AVK SURFACE BOXES

NEW TYPE 3583

The AVK product range is extended with new versions of the 3583 type surface box, fixed height and height adjustable. The dimensions are according to DIN 3583 and the design meets the DVGW VP310-2 standard.

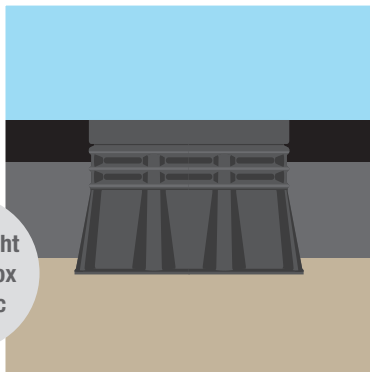
Unlike the previous version, the new fixed height 3583 surface box is made out of one piece. This eliminates the need for welded side plates and offers an increased strength of the fully injection moulded surface box.
